**DESIGN REVIEW**

***LAVITA APARTMENT***

**4055 8th Ave NE**

**DPD Project # 3012892**

## SITE PLAN & 1st FLOOR PLAN

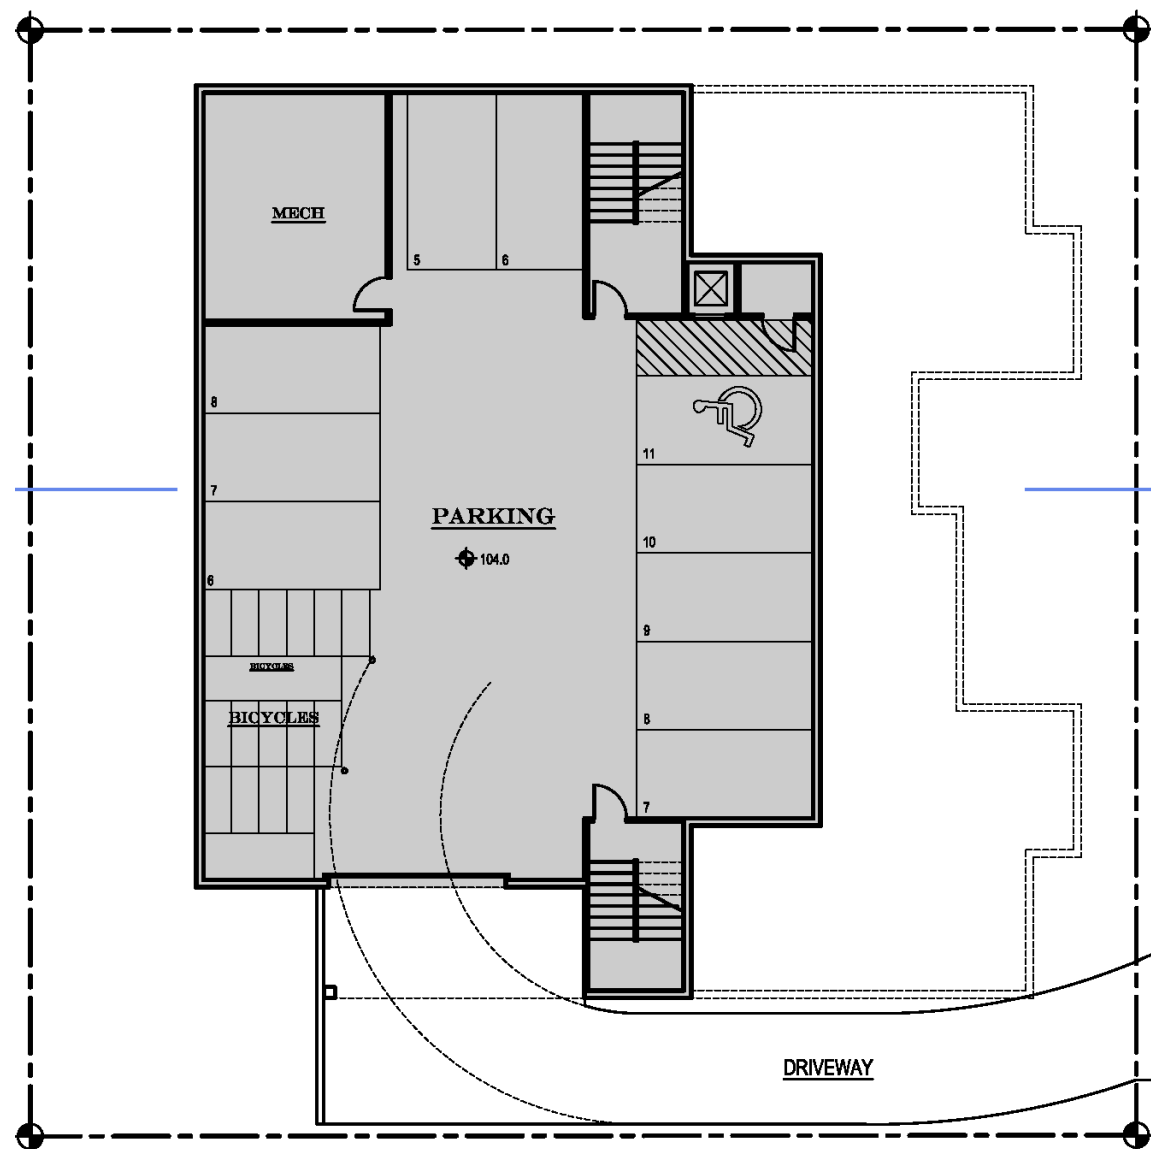
In order to ensure building security, the Board suggests 1) installing fencing along the lower portion of the driveway to prevent people wandering into the rear open space and 2) placing a gate between the north property line and the northeastern most unit. The Board did not think it necessary to provide security fencing around the entry patio.

Response:

Fence and gate location has been shown on ground floor plan and it prevents the non-residents' access to rear

**BASEMENT PLAN**

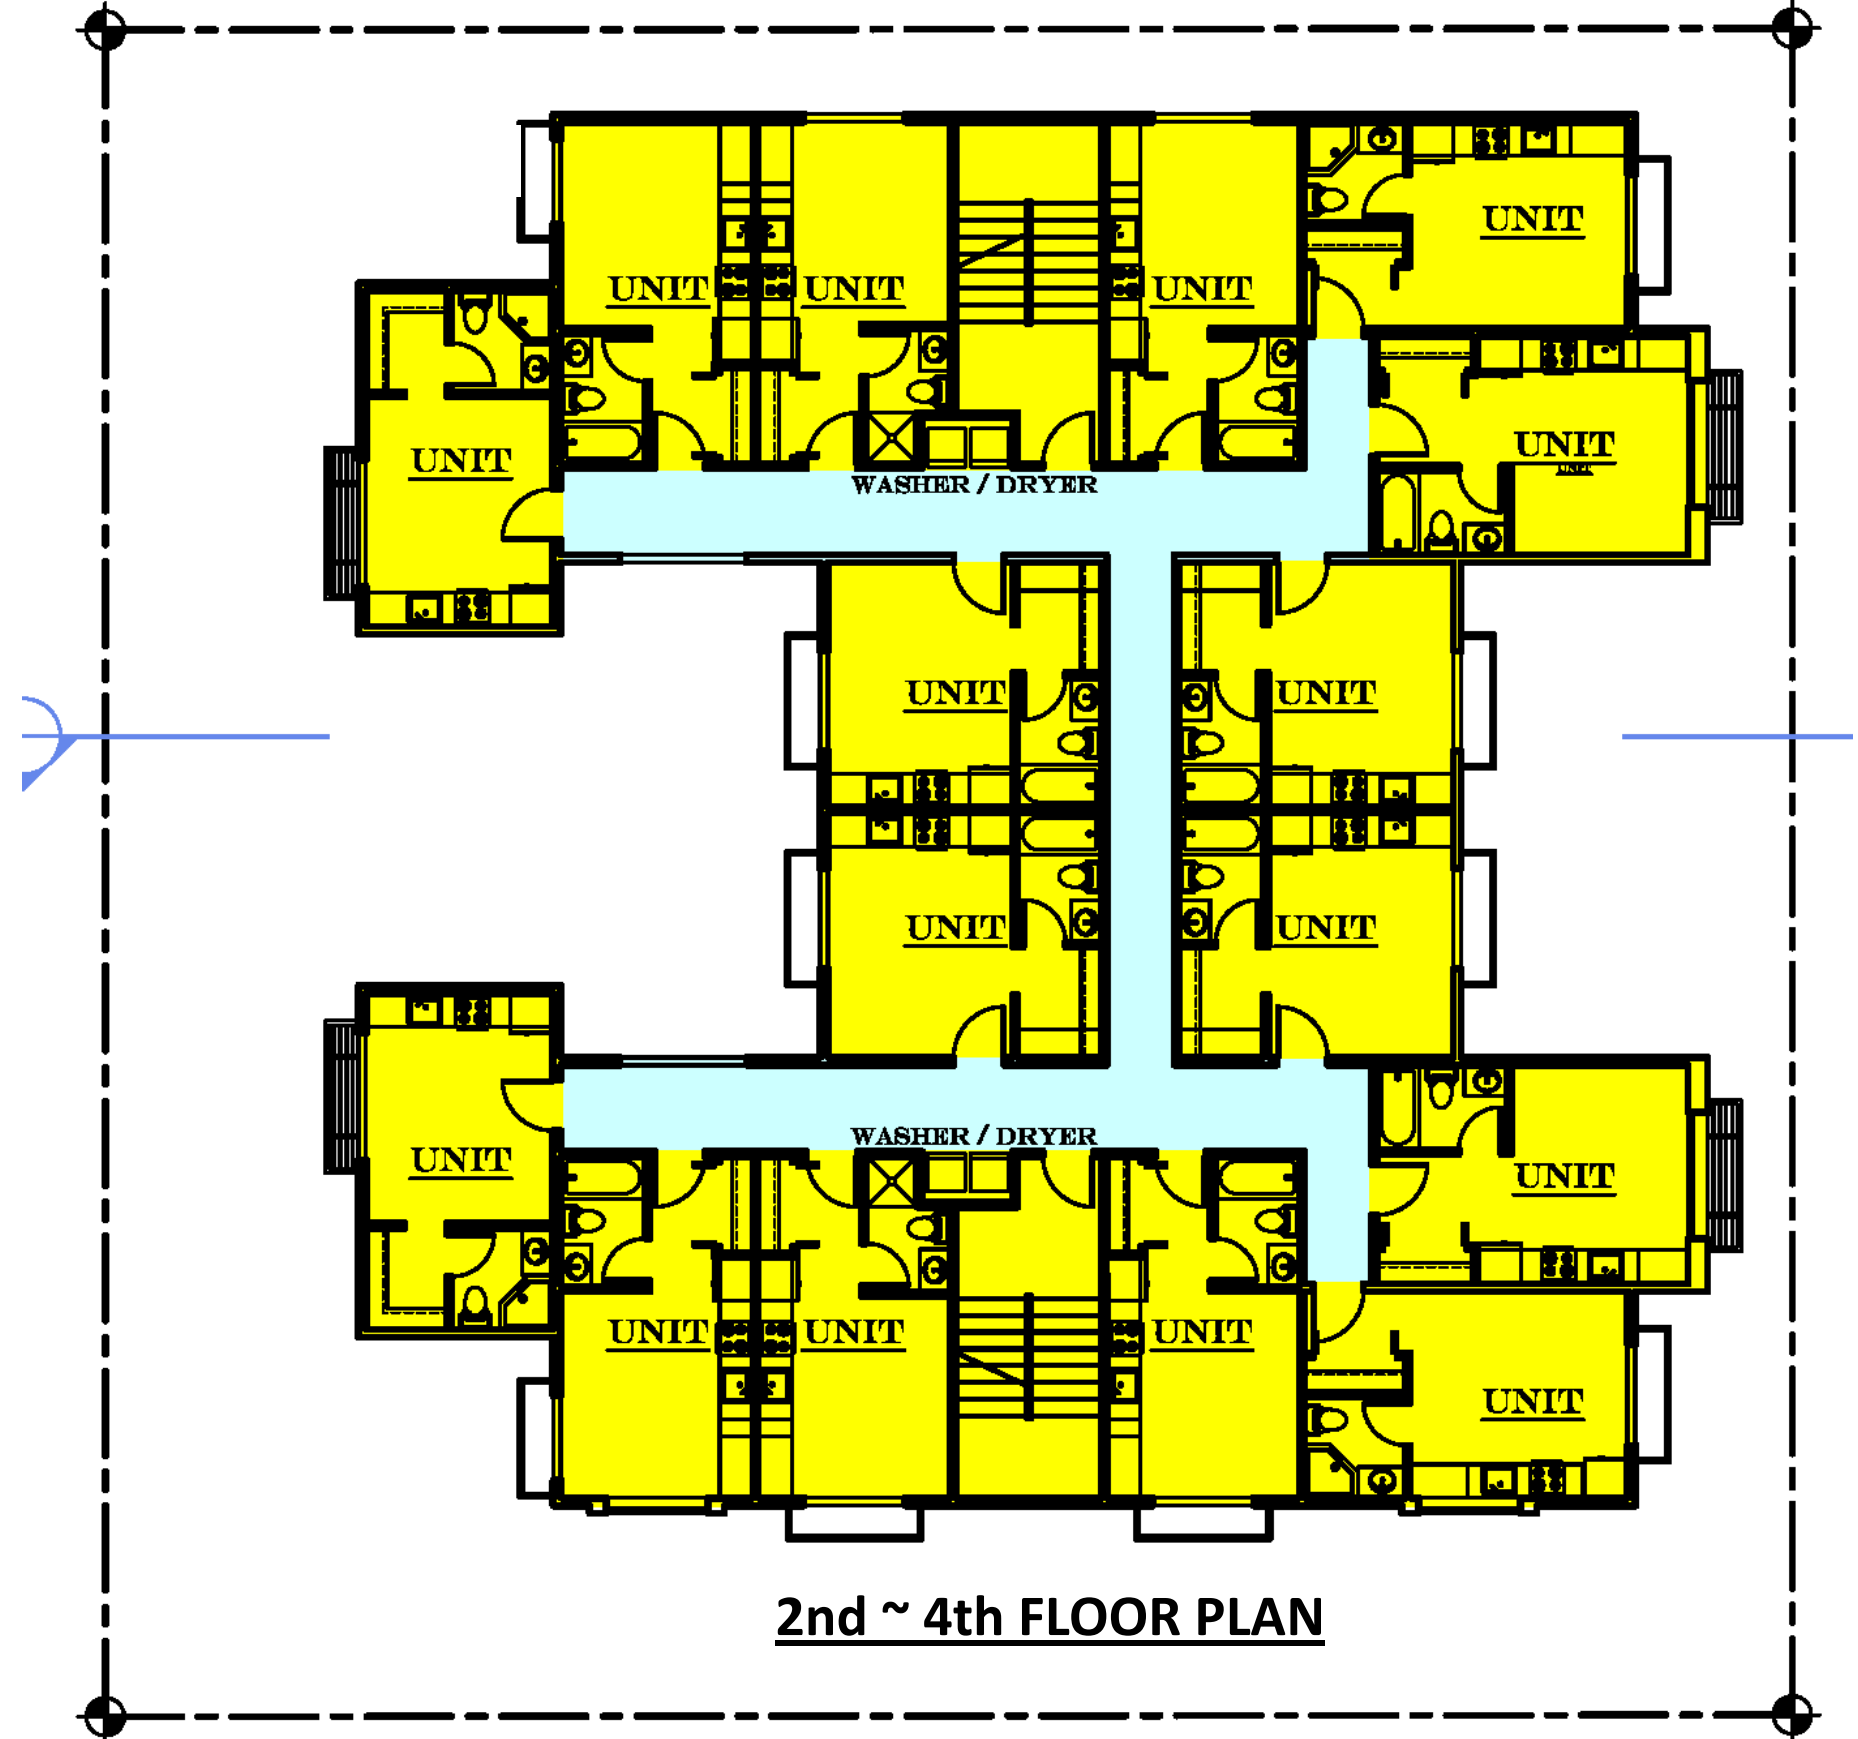
The change in location of the solid waste storage area from fronting onto 8<sup>th</sup> Ave NE to behind one of the units met with the Board's approval. The Board noted the harshness of the laundry room due to its size, lack of windows, and location with the garage. The architect ought to consider integrating the laundry room for this 60 unit apartment into the life of the building.

Response:

Two sets of washer and dryers are proposed to be along corridor on each residential floor for residents' convenience.

## EAST ELEVATION

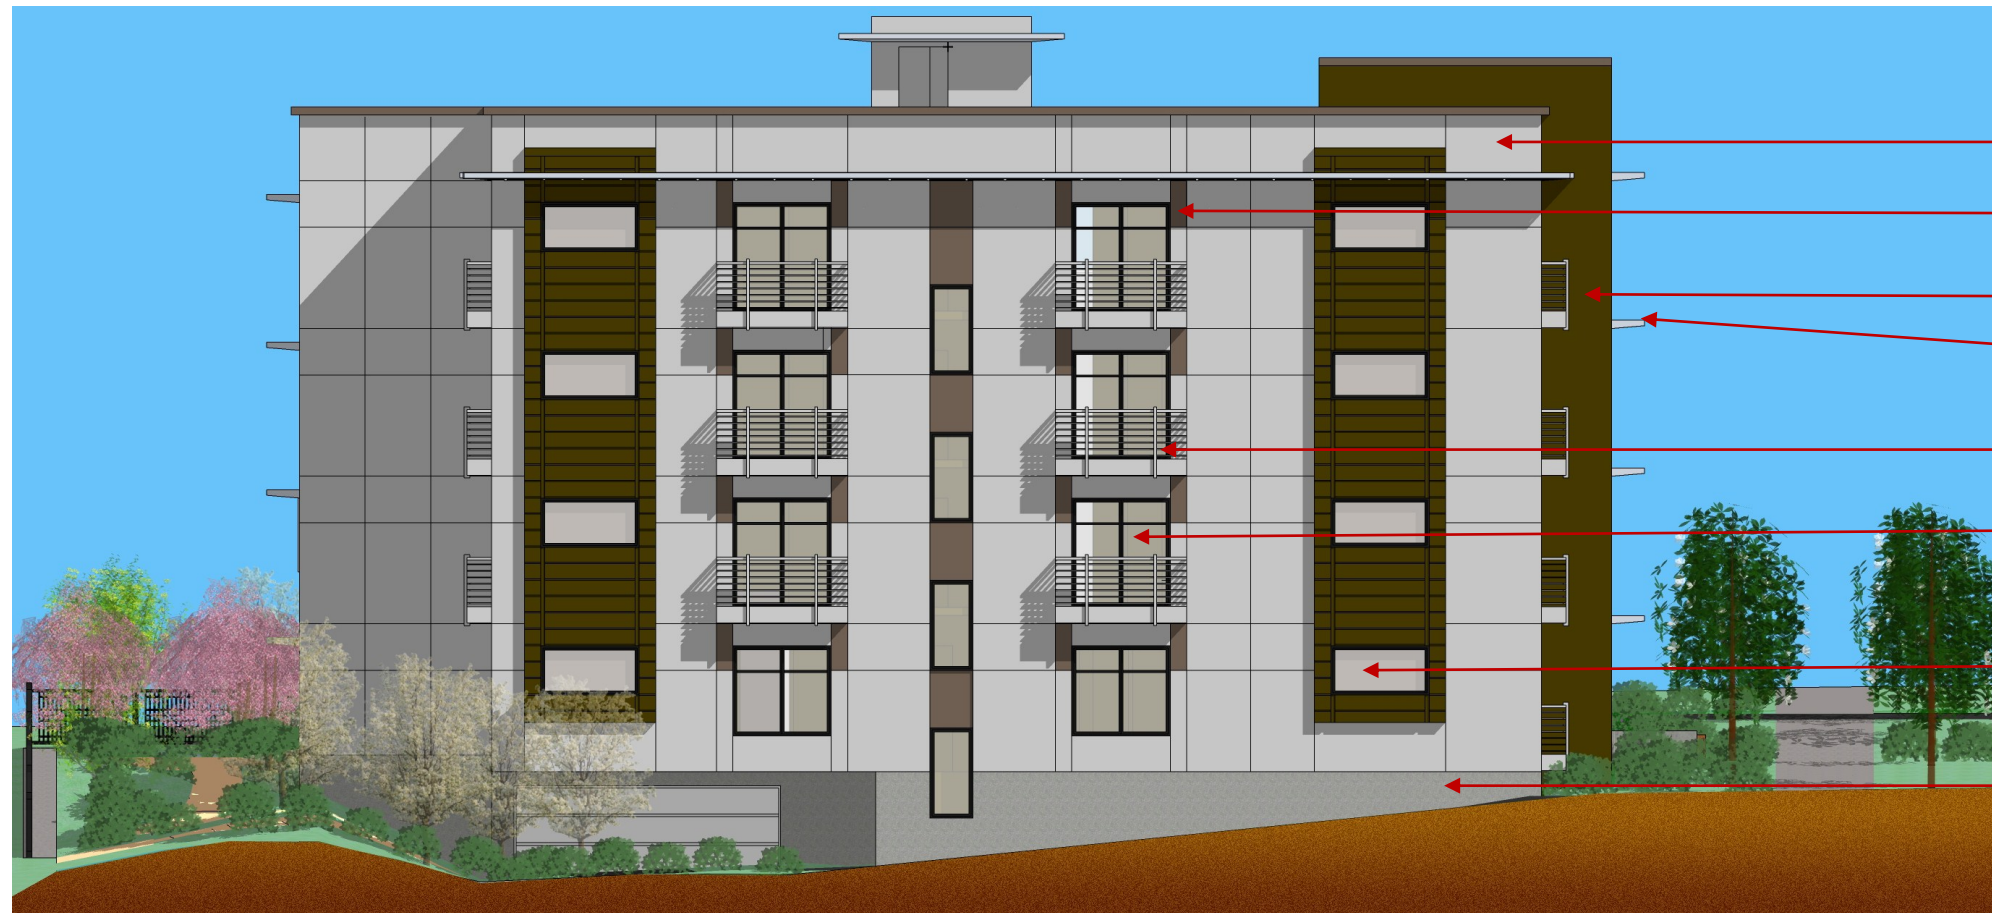
**E-2**  
The proposed landscaping design received praise. However, the Board requested that the fencing along the perimeter of the site be changed from a cyclone or chain link to one possessing better quality and nicer design. Other types of fencing will accommodate vines.  
The size of the roof deck appears larger than the occupancy that one stair access will allow. The architect should consult the building code. Building code experts are also available to review this design at DPD’s public resource center. Instead of using fencing as means to achieve the department’s green factor requirement, portions of the roof (i.e. green roof) may be used to meet this zoning regulation. The Board notes the placement of a tree in a landscaping drawing in front of the fin.

Response:

- Fence type has been changed.
- Roof garden design is modified for lower occupant load. (See both responses on landscaping plan as well)

**NORTH ELEVATION**

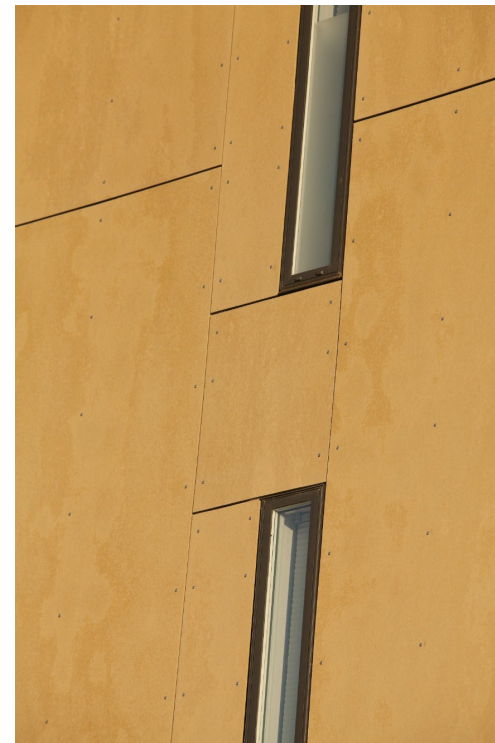
The Board questions the consistency of several elements of the design. The curve of the canopy appears unrelated to any other design element of the design. Should the architect desire to keep the canopy shape, he should relate it to another element of the overall design. The Board wants to see a detail of how rain is captured by the canopy (i.e. a gutter) so that it does not pour on people entering and exiting the building. Copper weathers and changes color. Show the canopy's appearance once it ages.

The diagonal struts on the balconies lack consistency with the other architectural elements and appears dated. The Board asks the architect to reconsider the design.

The sunscreens act as both a functional element and as an aesthetic device emphasizing the building's horizontality. The Board urges the architect to limit the application of the metal sunscreens to the areas above the windows.

The Board also questions the logic of the vertical fin on the east elevation but had not specifically request a change.

Response:

Curved entry canopy has been replaced with aluminum louver shade matching the same elements at other locations on the building. Entry wall is recessed for another 2' for better weather protection.

Diagonal railings of metal balconies have been replaced with horizontal struts with vertical supports.

Aluminum louver shades have been reduced in length. Vertical fin on the east elevation has been shortened for necessary separation function and integrated with entry louver shade.

# LANDSCAPE DESIGN PLAN

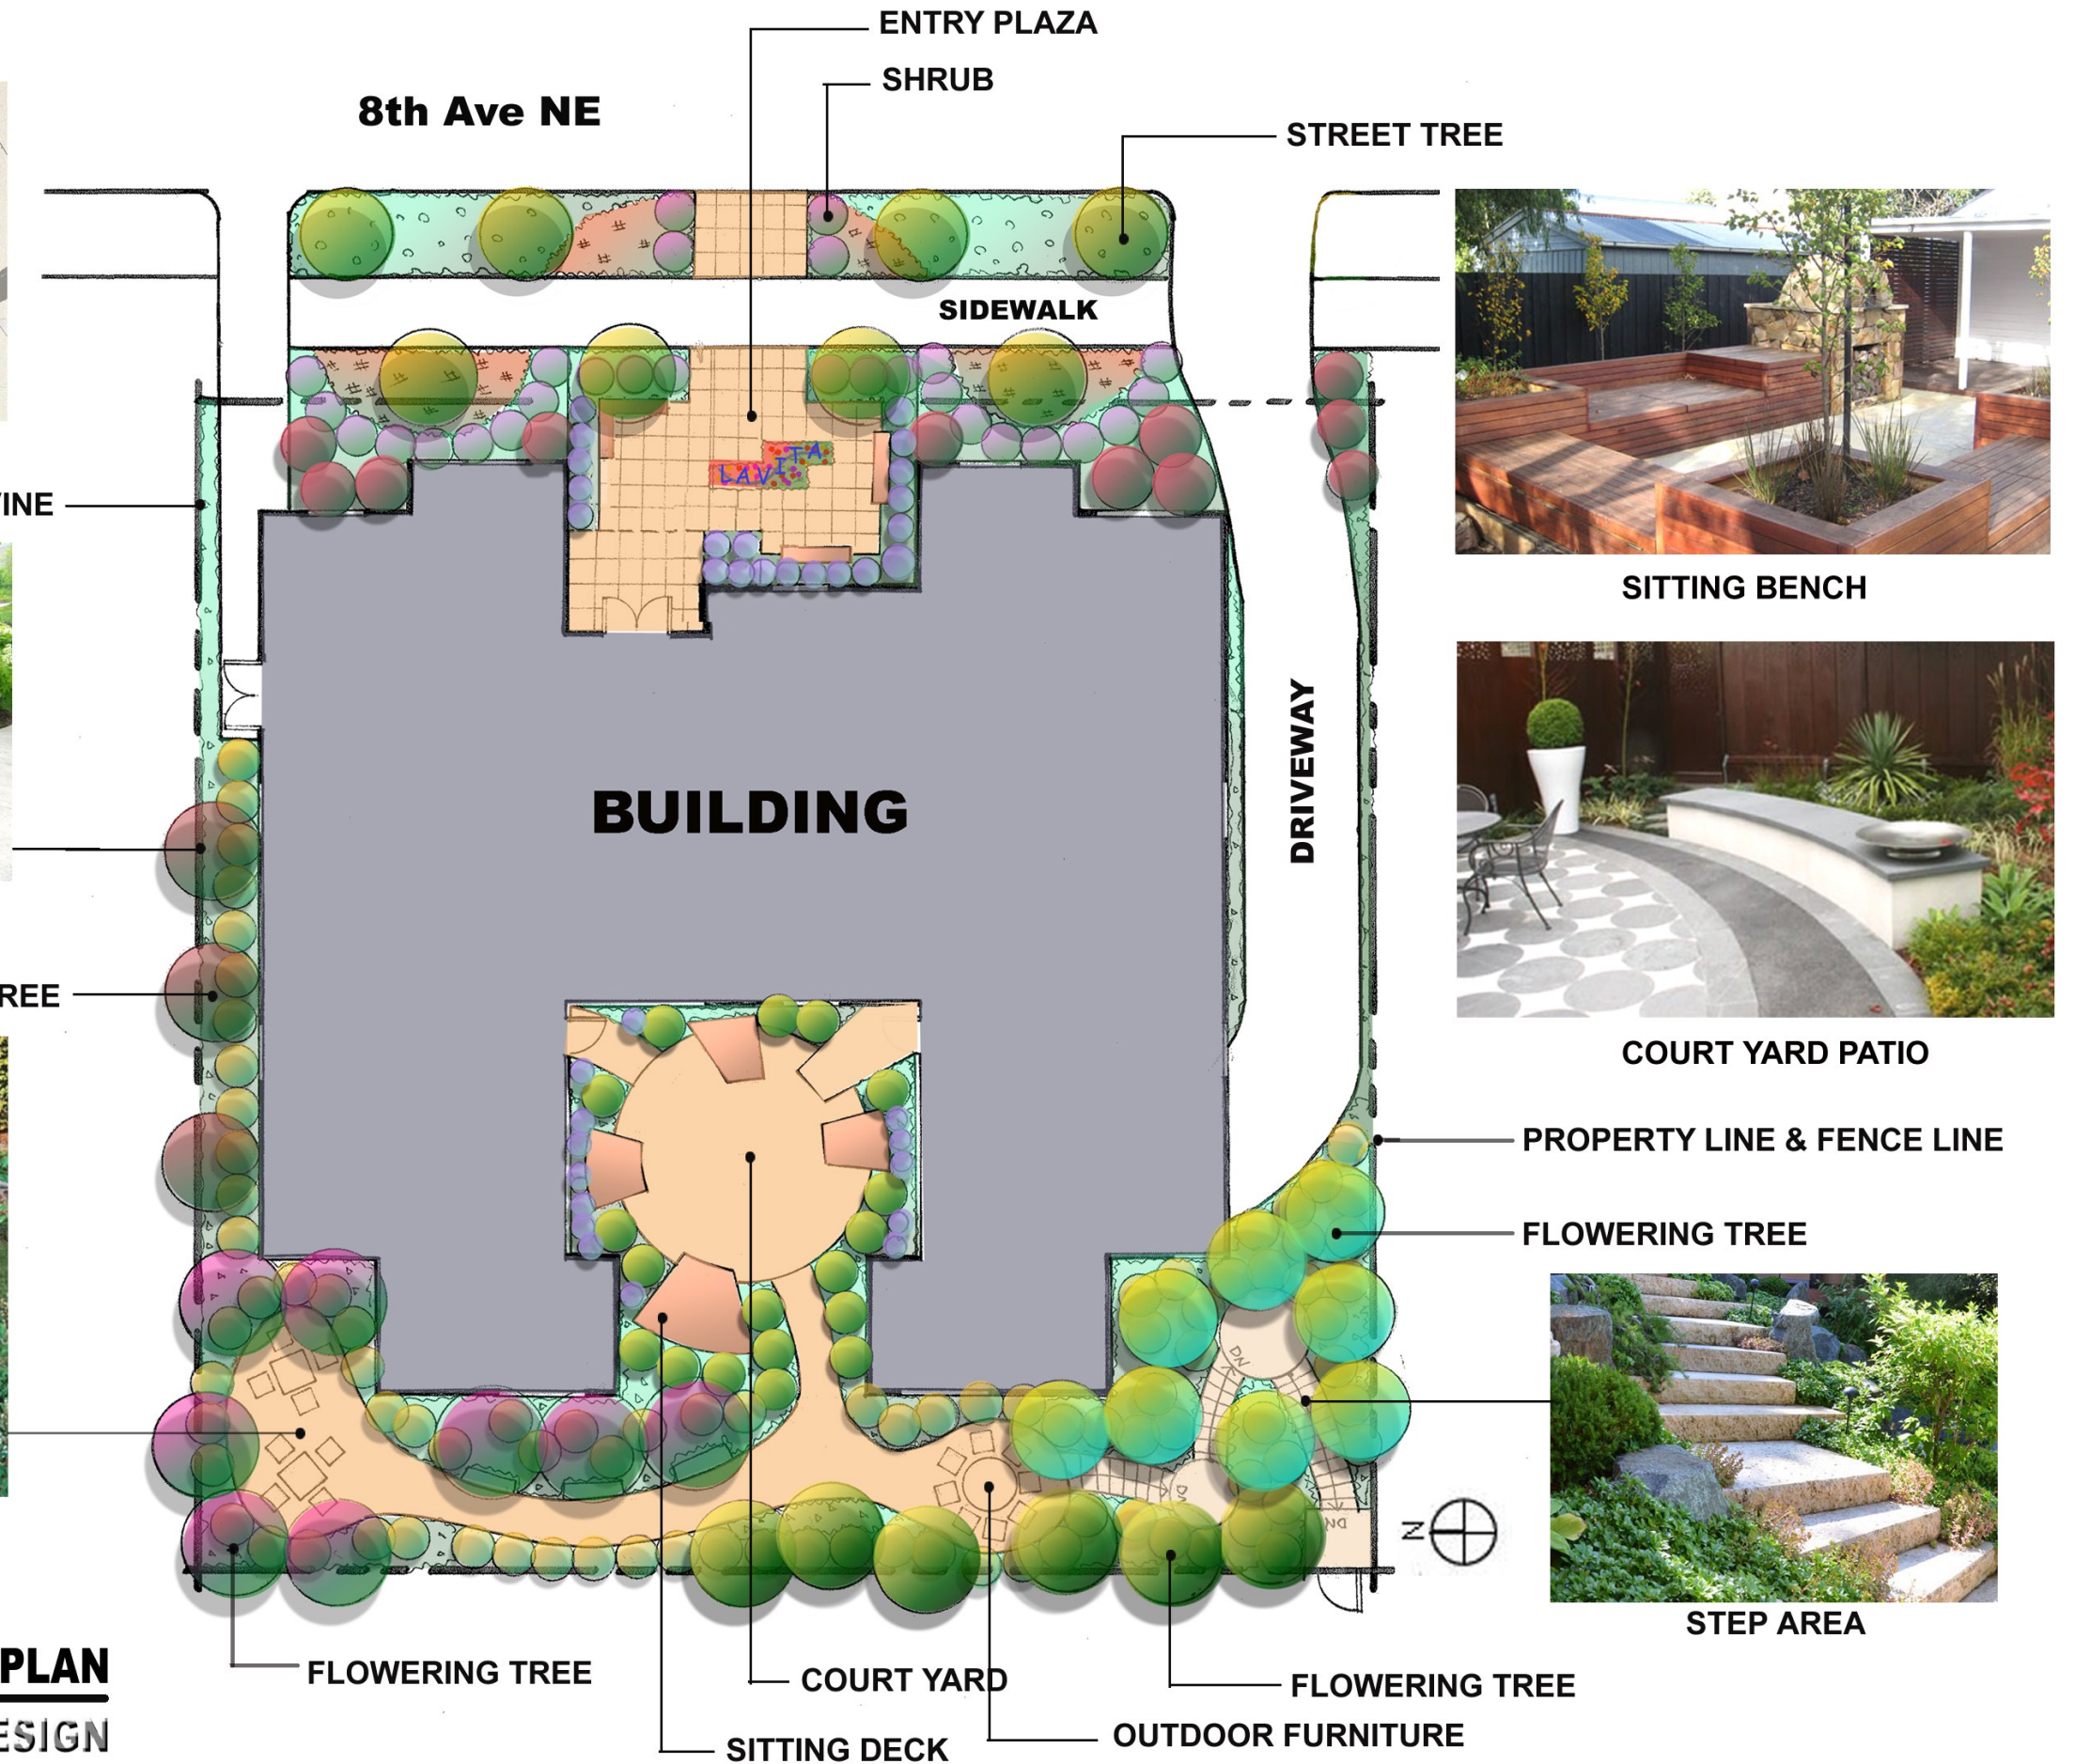
The Board praised the revisions to the open spaces and their flow or sequence from one to another. The architect and landscape architect ought to contact SDOT to decide whether the planter boxes in the right of way (adjacent to the sidewalk) will be allowed.

Response:

The planter boxes on the right of way have been replaced by landscaping on grade.
